SAN FRANCISCO PLANNING DEPARTMENT

MEMO

RE: Review and Comment for 88 Broadway/ 735 Davis
Case No. 2016-007850COA

CERTIFICATE OF APPROPRIATENESS - REVISION 2

A3.3 LMSA

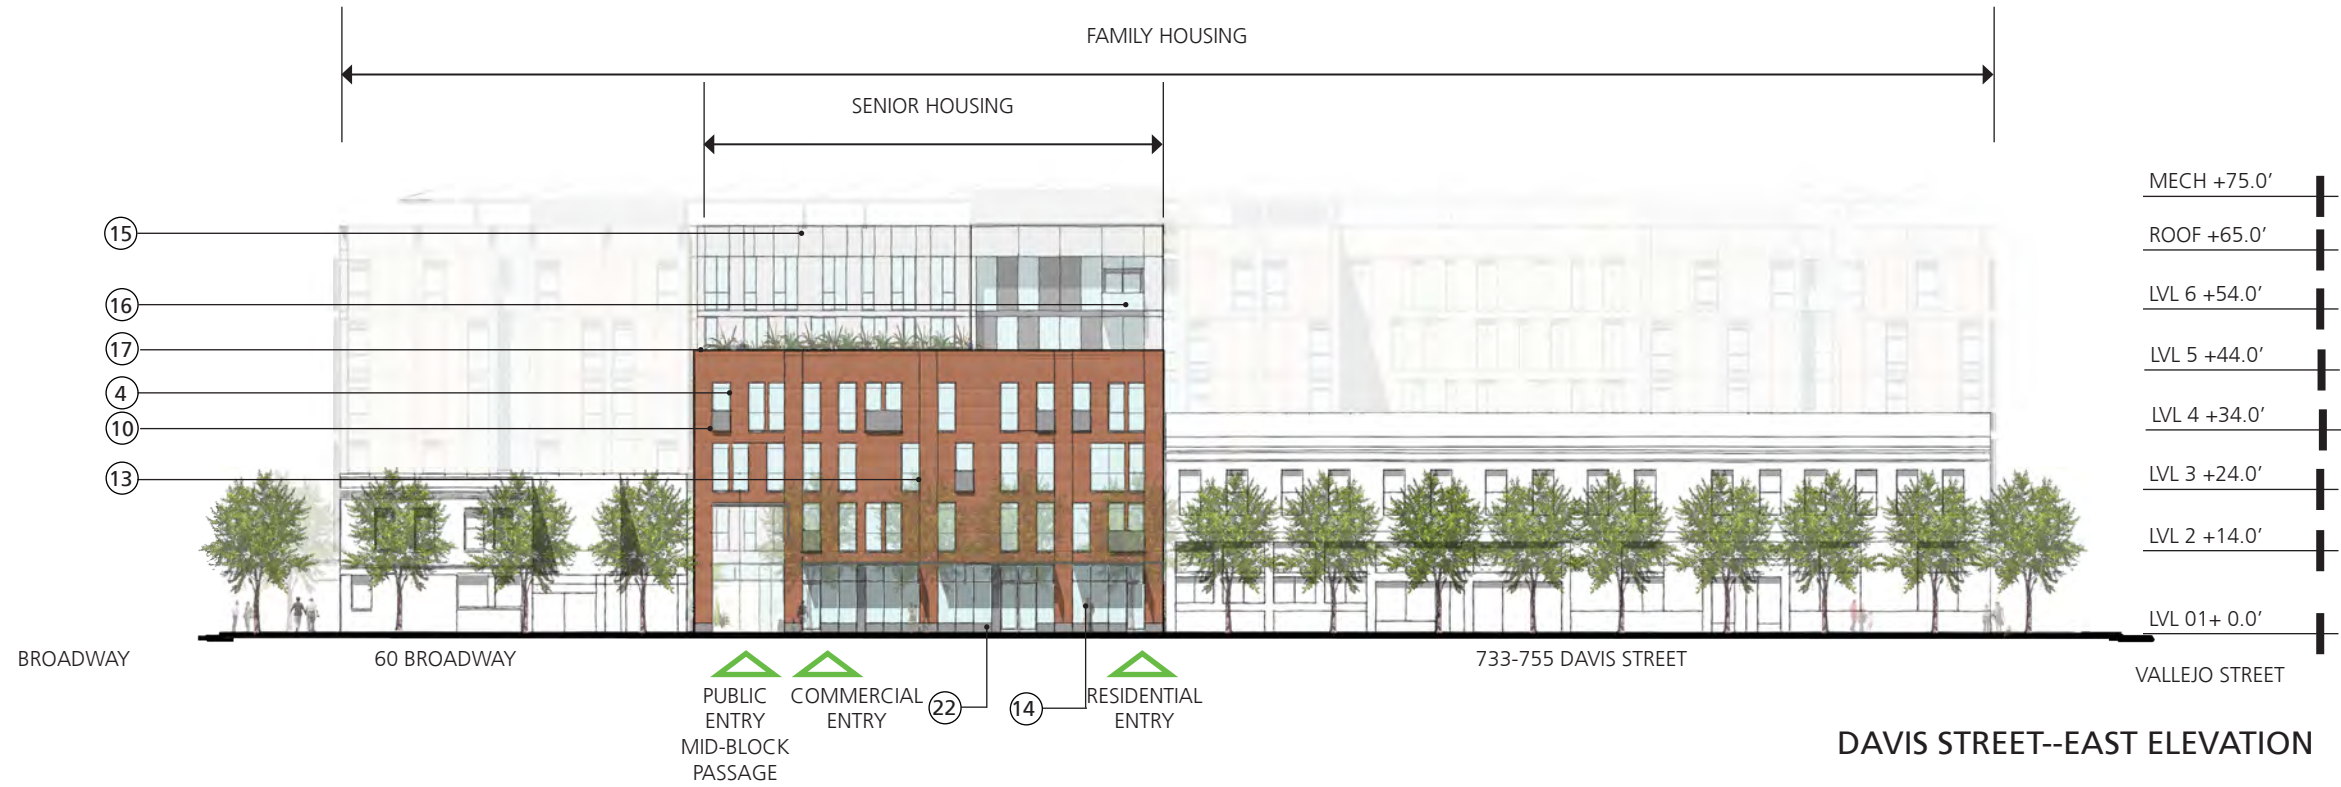
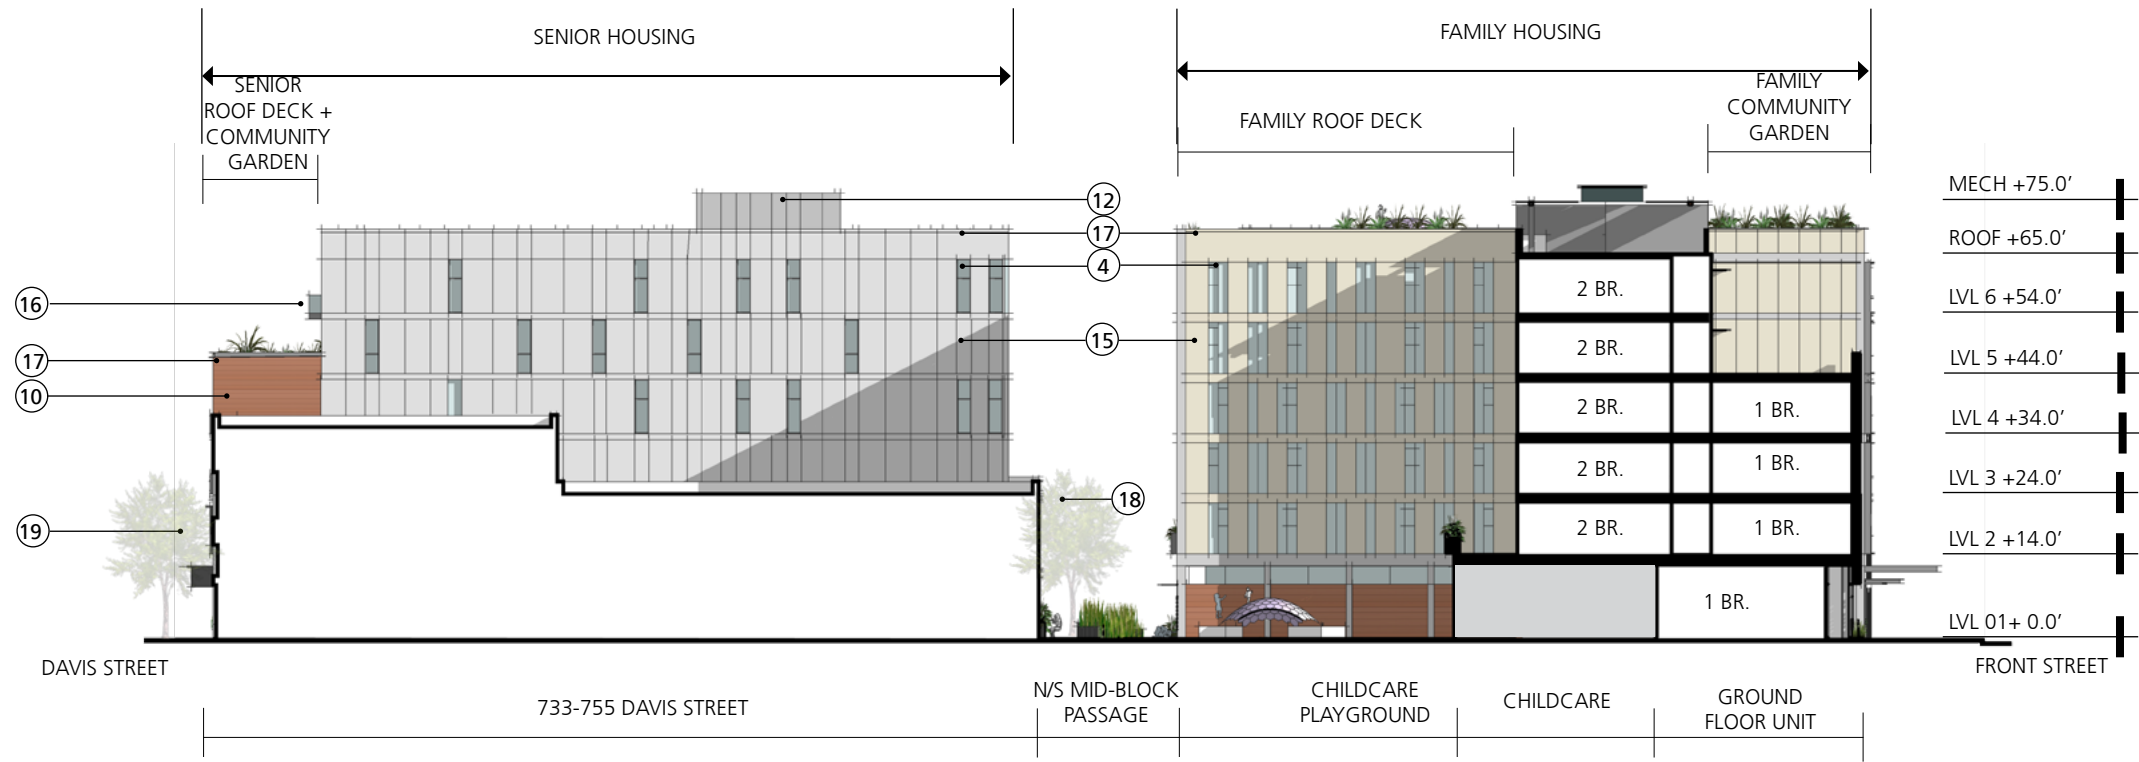
Recommendation 2: Study a modified fenestration pattern for the frame and infill building elevations on Front, Broadway and Vallejo Streets. At minimum, Staff recommends two approaches for ARC direction to sponsor for study and possible incorporation into the frame and infill fenestration pattern, within technical confines for building performance. One option is to shift the orientation to horizontal and increase consistency of glazing. Another option is to maintain the existing orientation while increasing the glazing from one panel to two, within the three panel system created for the project.

Frame and Infill Building (88 Broadway). The frame and infill building is clad in two primary panel systems – the grey Minaret “frame” cement panels and the light-colored Cembrit “infill” cement panels. The module system, joints from the horizontal and vertical panel design, and face-fixed attachments add some shadow lines and texture. (For reference, please see Details on Sheets A8.0, A8.1, A8.4, and elevations on Sheets A3.3, A3.4).
